93-RF-7137

OPERABLE UNIT NO. 5 (OU 5), MONITORING WELL LOCATIONS - IHSS 115 - ORIGINAL
LANDFILL - WSB-282-93

PROPOSED MONITORING WELL LOCATION MAP

IHSS 115 ORIGINAL LANDFILL MONITORING WELL INSTALLATION PLAN

| | 9208.15.01.18 | FIGURE 1 |

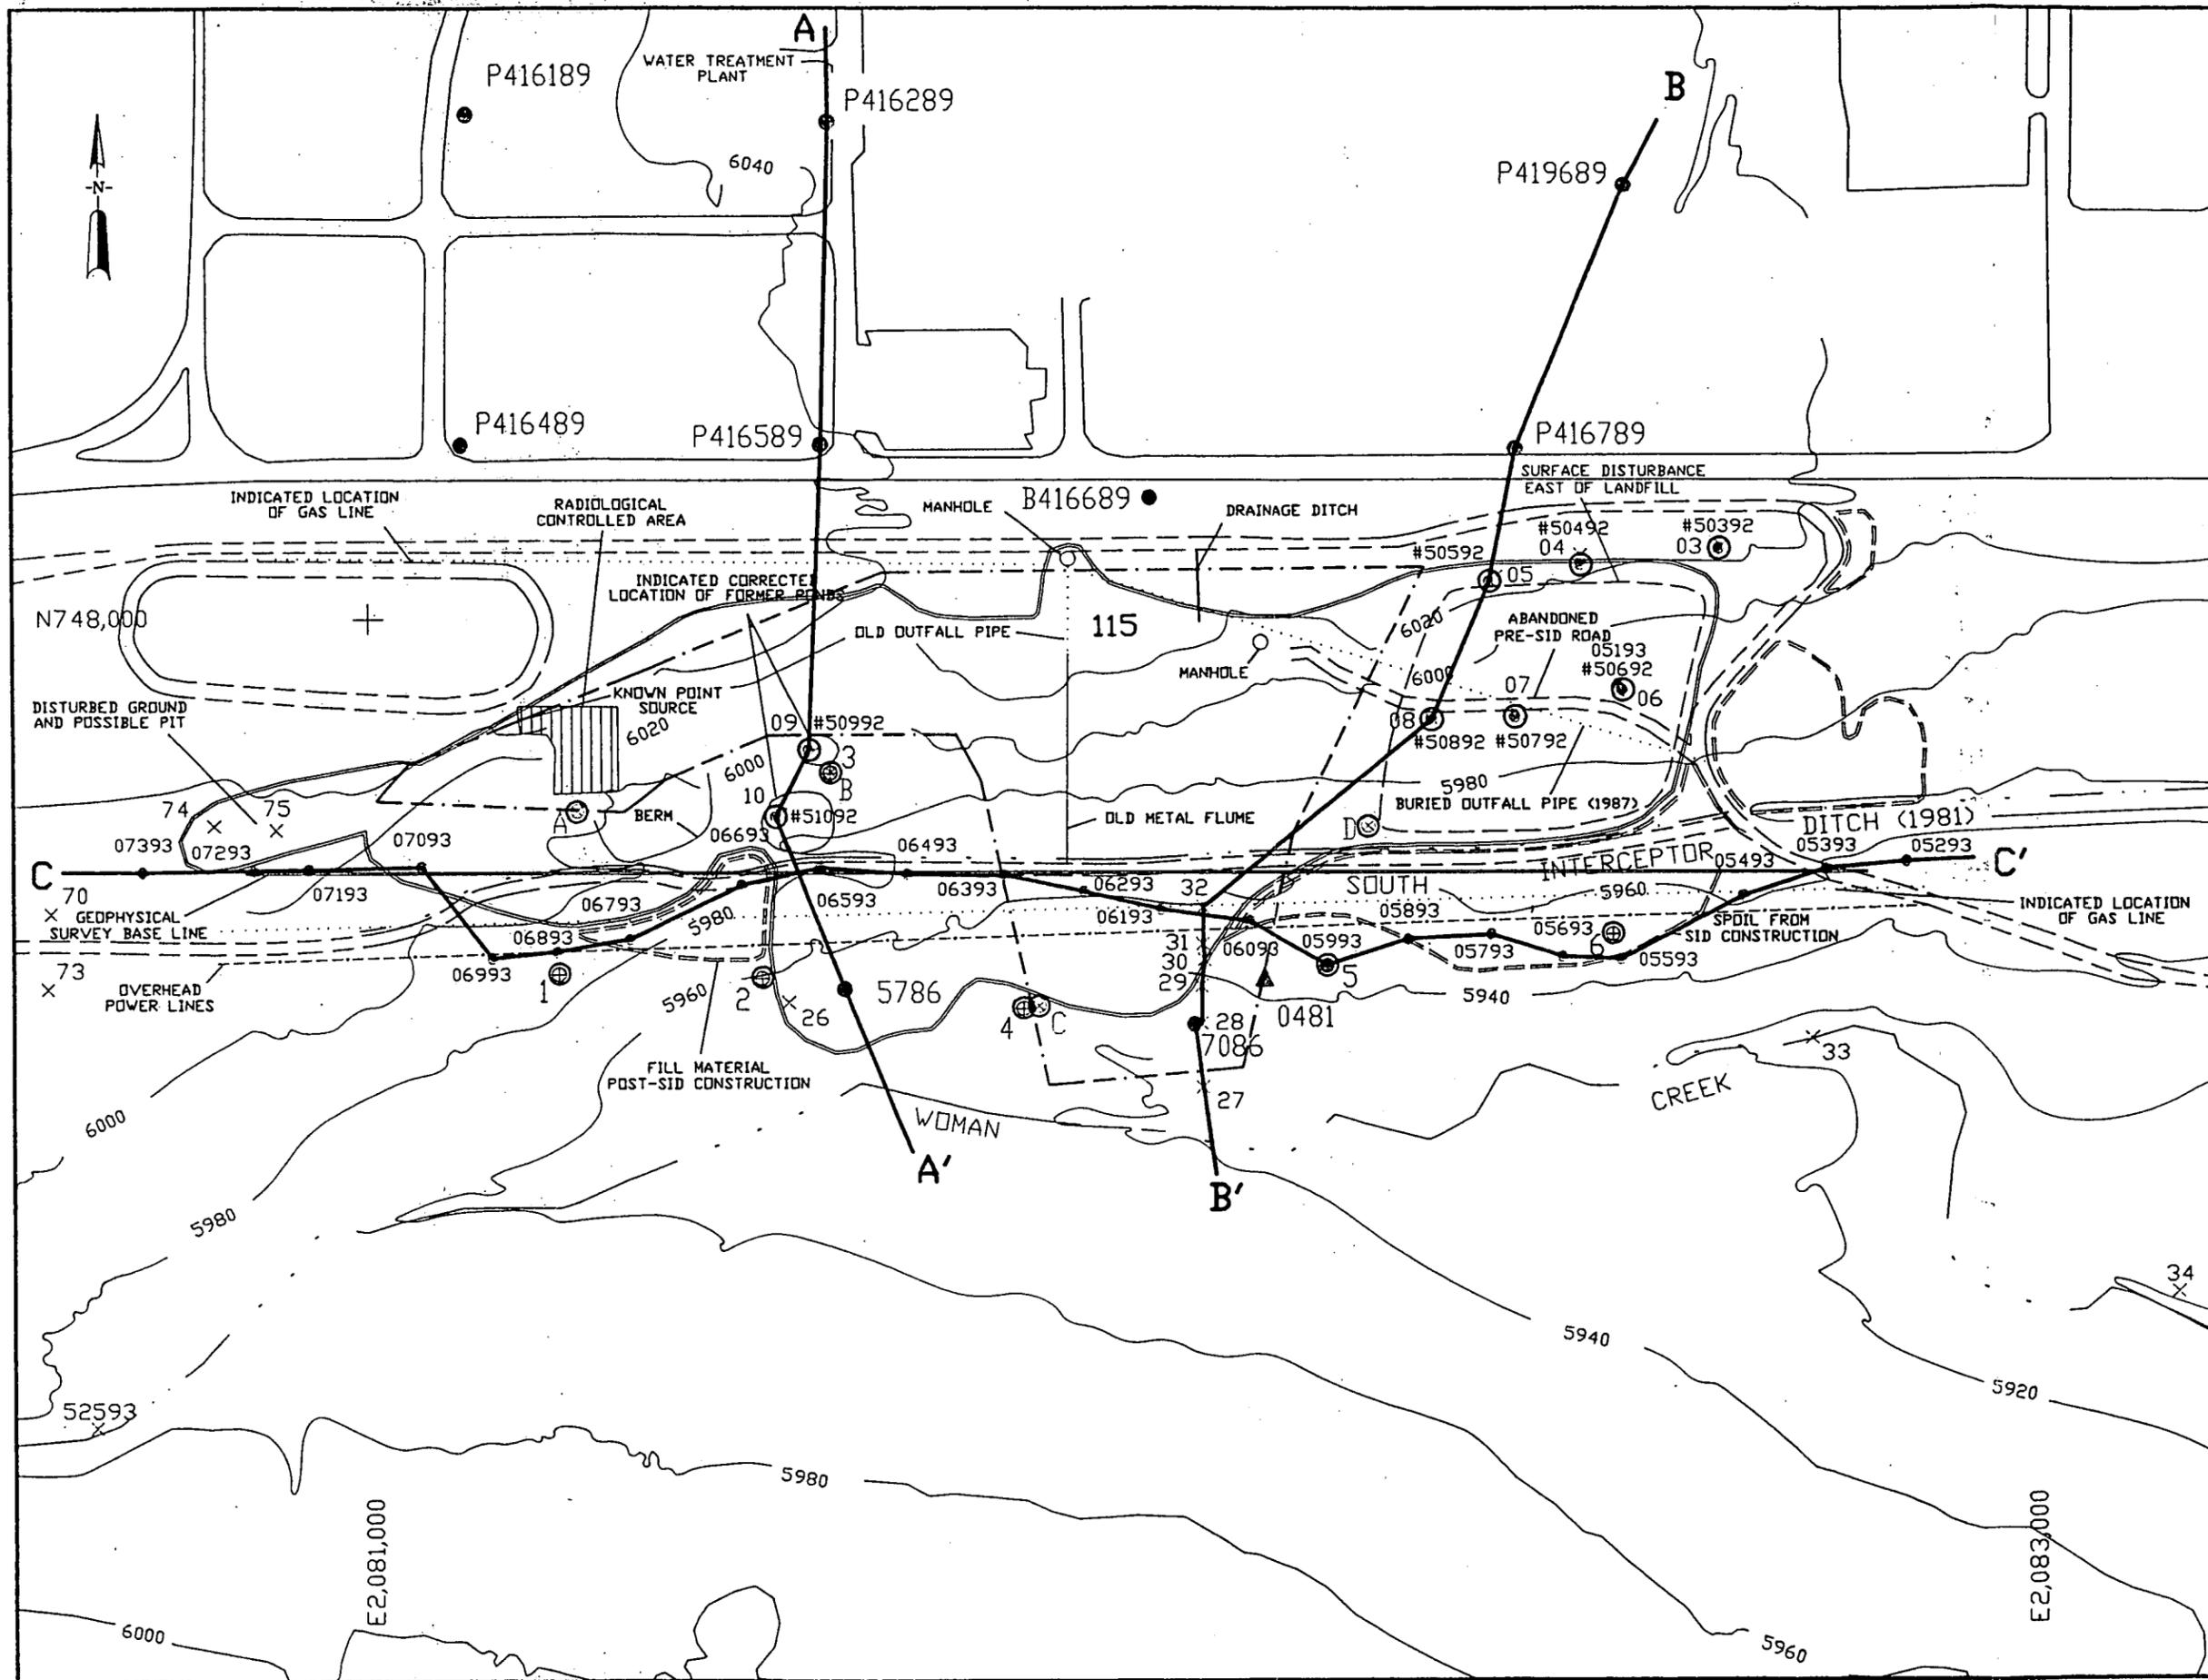
one well installed between the SID and Woman Creek (Figure 1). At the time the OU 5 Work Plan was being written, the original boundary of the Landfill had been characterized principally from reviews of historic aerial photographs and from the operational history of the site. The eastern and southern boundaries of this IHSS, as characterized by these reviews, have since been extended based on EPA and CDH investigations (TM 6). The southern boundary was extended because waste was identified in areas south of the SID. The eastern boundary was extended because a surface disturbance area east of the Landfill once served as a pipe and scrap metal storage yard and possibly a soil disposal area concurrent with, and following operations at, the Landfill. Radiological and geophysical (electromagnetic and magnetometer) surveys conducted as part of the Phase I RFI/RI investigation have yielded additional information that indicates the old Landfill boundary and disturbed area extend to the east, south, and west of these limits.

The intent of the OU 5 Work Plan was to monitor the groundwater downgradient of the original Landfill. In order to keep the intent of the OU 5 Work Plan intact, the proposed locations of two of these four monitoring wells have been adjusted and two additional monitoring wells are proposed to be added to the groundwater monitoring program. Figure 1 identifies the original OU 5 Work Plan proposed locations as A, B, C, and D (Phase I RFI/RI Work Plan, Figure 7-1). The revised proposed well locations are identified as 1 through 6. The following provides a rationale for these revised locations on a well-by-well basis.

Well location A has been moved approximately 200 feet to the south and renamed well location 1. This locates the well downgradient of any suspected waste. The preliminary CPT survey data (from site 06893) indicates a low area in the top of bedrock and the presence of groundwater in this area (Figure 3).

This new well is proposed in order to locate a well at the southern edge of the fill material and downgradient of any suspected waste.

Well location D has been moved approximately 150 feet to the south and renamed well location 5. This places the well south of the SID and downgradient of the Landfill. This also places the well in an area that overlies a bedrock low (Figure 3), where groundwater is present in the alluvium as indicated by the CPT survey at location 05993, and in a probable channel incised in bedrock (Figure 4).

| | 0208.15.01.18 JUNE 9, 1993 | FIGURE 3 |

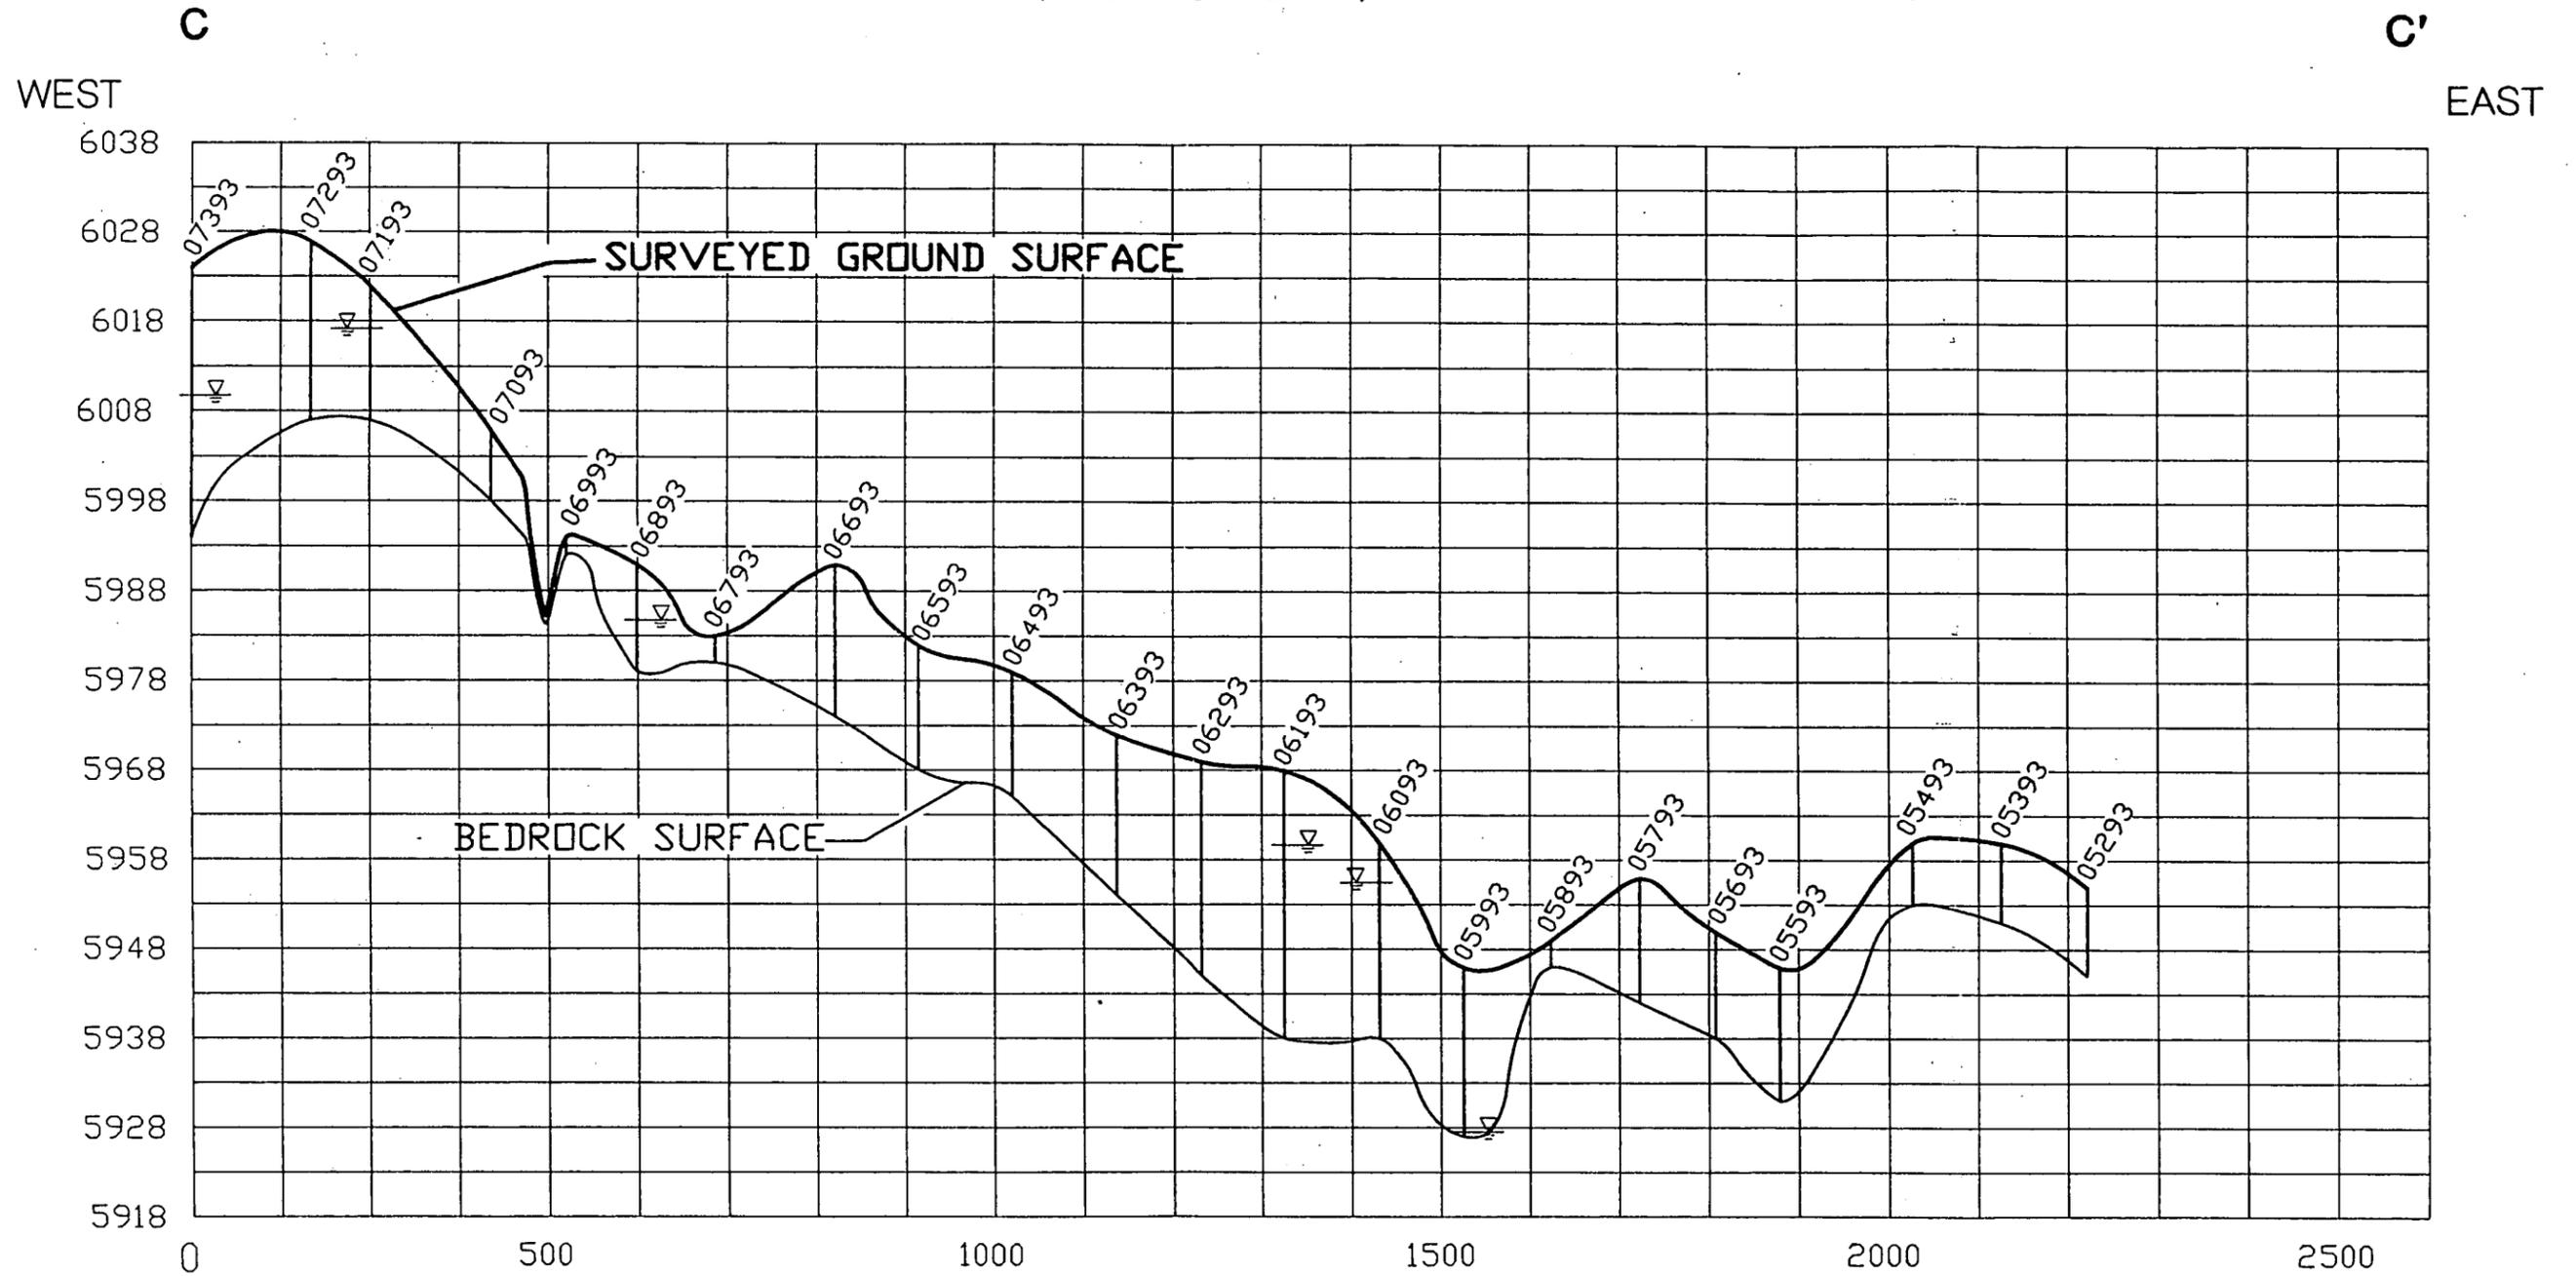
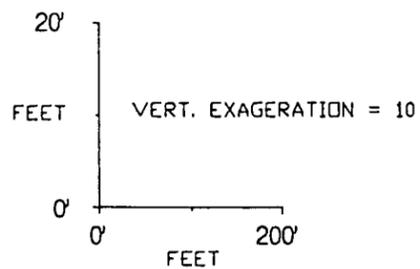
This new well location is proposed in order to have a well downgradient of the eastern end of the Landfill. The well is proposed to be located at CPT location 05593 because the CPT survey indicated an underlying bedrock low (Figures 3 and 4). A visual review of the ground surface in this area reveals two seeps to the north of the location that is probably evidence of groundwater.
